**Murraylink Transmission Company**  
Application for Conversion of  
Murraylink to Prescribed Services

TransGrid's Submission to the ACCC

*March 2003*

### **Plant and Costs**

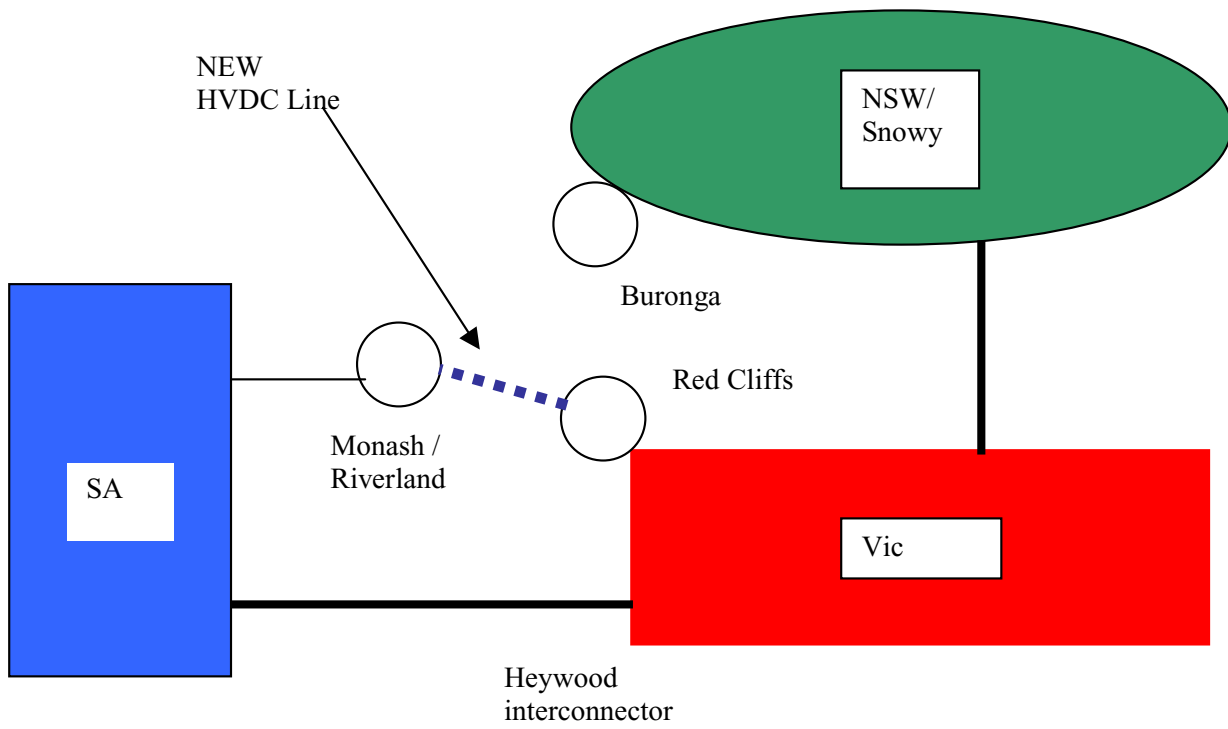
However, TransGrid notes the following issues with the cost provided:

- (g) mention is made of “Augmentation of existing plant due to impact of new interconnection with increased fault levels”. No details seem to be provided and these details are required to provide further comment, and

The cost of Alternative 1 is quoted at \$246M compared to an overhead line development that would be of the order of \$40-50M. Hence the cost of undergrounding, power flow control and voltage control add significantly to the cost. This increased cost is a direct result of MTC's decision to only select alternative projects that are technically the same as Murraylink. However, as discussed above, this approach is based on a standard of service significantly in excess of that provided for under the Code for a regulated interconnector. Given this, as set out in that section, if this approach is adopted then substantial "*gold-plating*" would be entrenched in Murraylink's asset base.

### **Plant and Costs**

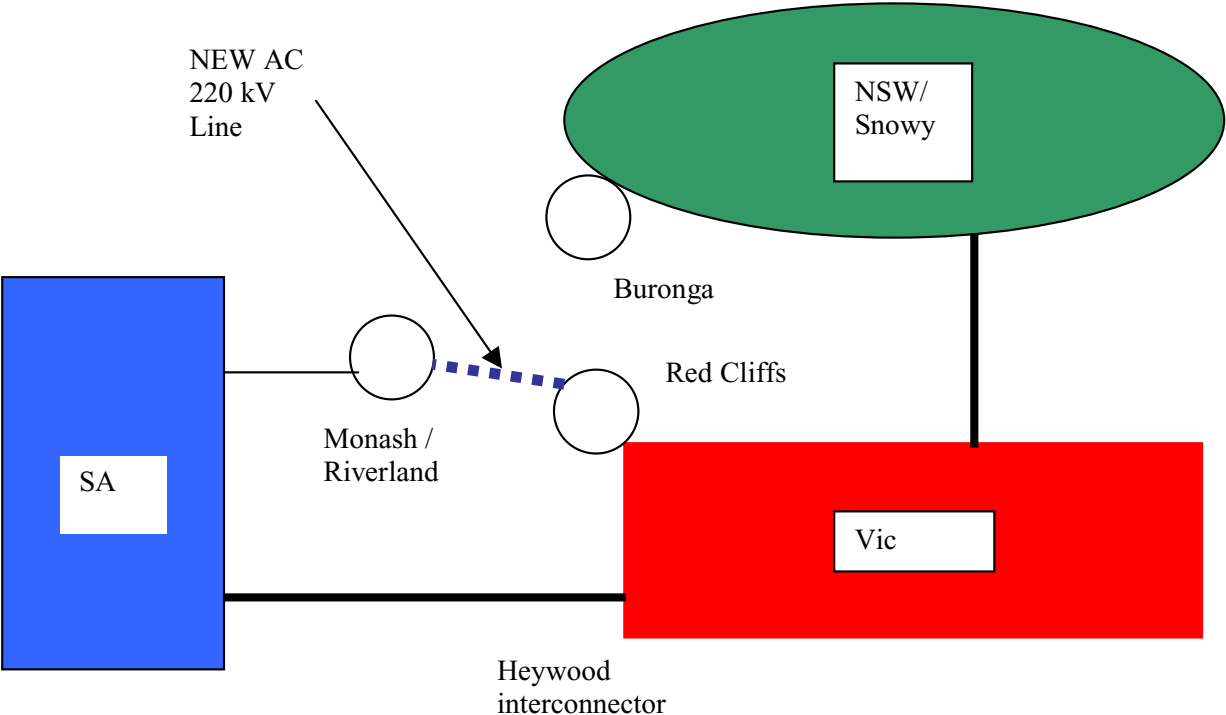
TransGrid's comments about the cost information for this project is as follows:

Spare converter transformers are included for each end of the link. It is not known whether such spares were purchased for Murraylink. In TransGrid's view only one dual voltage spare converter transformer is needed for Murraylink on the basis that it has three single-phase converter transformers at either end.

### **Power Transfer Capability**

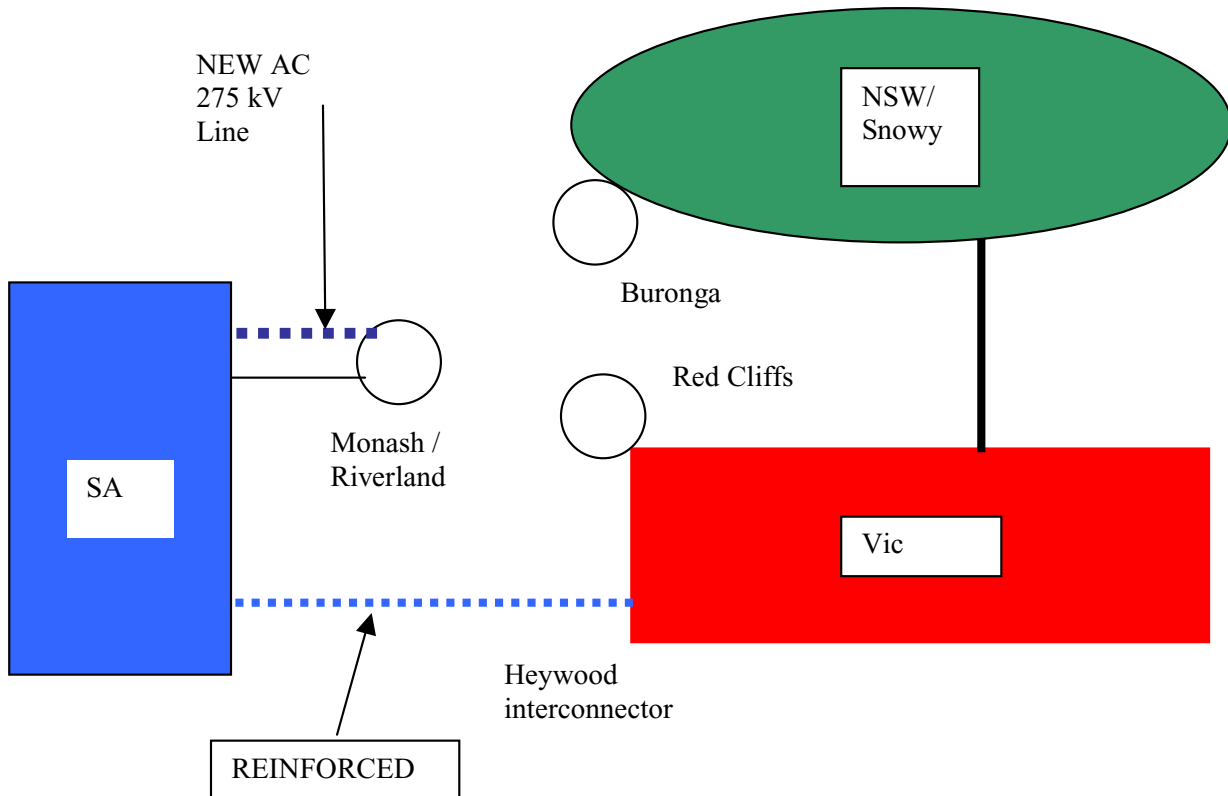
TransGrid notes that very limited details of power flow studies have been provided for this alternative and as a result there is no evidence supporting the need for all the plant associated with the alternative. Further analysis on the design is required to be certain of its capability.

It appears that BRW has not taken into account the fact that operation of this new line with power flow of the order of 200 MW would significantly stress the NSW 220 kV system.
